Access Compliance Report Public Rights-of-Way (Curb Ramps)

Main Street: THERESA_AVE		Cross Street: THISTLE_RD		Location:	N
ADA ID: RPRK210924173448	Ramp Type: Type 6 - Directional 1	Initial Pass/Fail: Pass	Overall Compliance: No	Severity Score:	7
Codes/Mitigation Info/Possible Solution			Field Measurements/Component Compliance

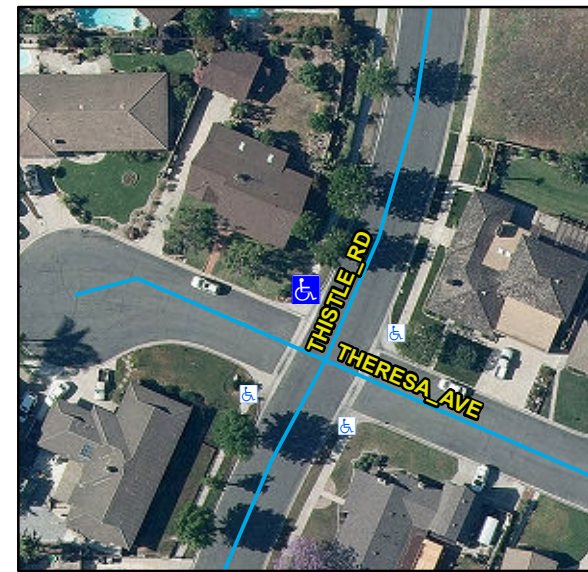
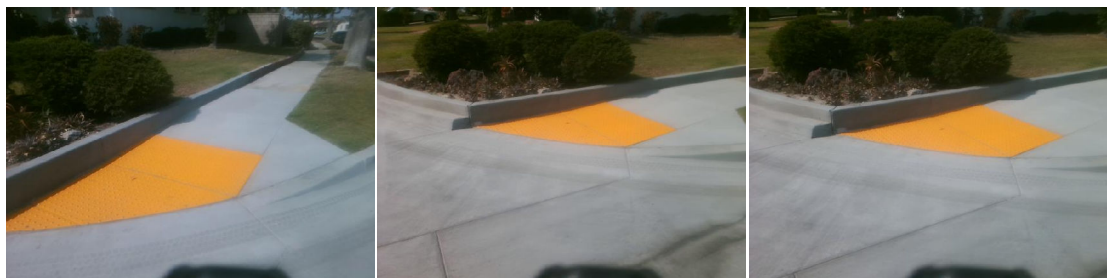
Compliance	Description	Data	Compliance	Description	Data
N/A	Ramp Length (in)	90	Yes	Flare Type LT	Curbed2
Yes	Ramp Width (in)	60			
Yes	Ramp Run Slope (%)	2.8	N/A	Flare Slope LT (%)	N/A
Yes	Ramp Cross Slope (%)	0.6	N/A	Flare Traversable LT	N/A
Yes	Grade Break	Yes	N/A	Flare Type RT	
Yes	Grade Break Slope (%)	1.4			Sloped
Yes	Grade Break Cross Slope (%)	1	N/A	Flare Slope RT (%)	5.1
	Addl Para Ramp Left?	No	N/A	Flare Traversable RT	No
	Addl Para Ramp Right?	No	Yes	DWS Provided	Yes
N/A	Landing Present	Yes	Yes	DWS Contrast	Yes
Yes	Landing Length (in)	87	Yes	DWS Length (in)	88
Yes	Landing Width (in)	60	Yes	DWS Full Width	Yes
No	Landing Run Slope (%)	4.1		DWS Offset Type	Single
Yes	Landing Cross Slope (%)	1	Yes	DWS Left Offset (in)	0
N/A	Landing Movement Obstructed?	No	N/A	DWS Right Offset (in)	0
	Landing Movement Type	N/A			
N/A	Landing Shared	No			
N/A	Marked Crosswalk 1	No	N/A	Clear Space	Yes
	Crossing 1 Direction	SW	N/A	Clear Space To Crosswalk (in)	48

Marked Crosswalk 1 Width (in)	N/A			
N/A	Ramp Inside Crosswalk 1	N/A			
	Crossing 1 Slope (%)	0.8			
	Crossing 1 Cross Slope (%)	0.1			
Yes	Gutter Ponding	No	Yes	Curb Slope	5.1
Yes	Gutter Lip Height (in)	0		Road Run Slope (%)	0.6
No	Gutter Run Slope (%)	6.5		Road Cross Slope (%)	7
Yes	Gutter Cross Slope (%)	0.5		Parallel Ramp Side	Left
Yes	Overall Surface Condition	Acceptable	Yes	Perp Joint Present	Yes
	Cross Gutter Present?	Yes		Spandrel Present?	Yes
	Replace Cross Gutter?	No		Replace Spandrel?	No

Remove & Replace Landing. Remove & Replace Gutter.
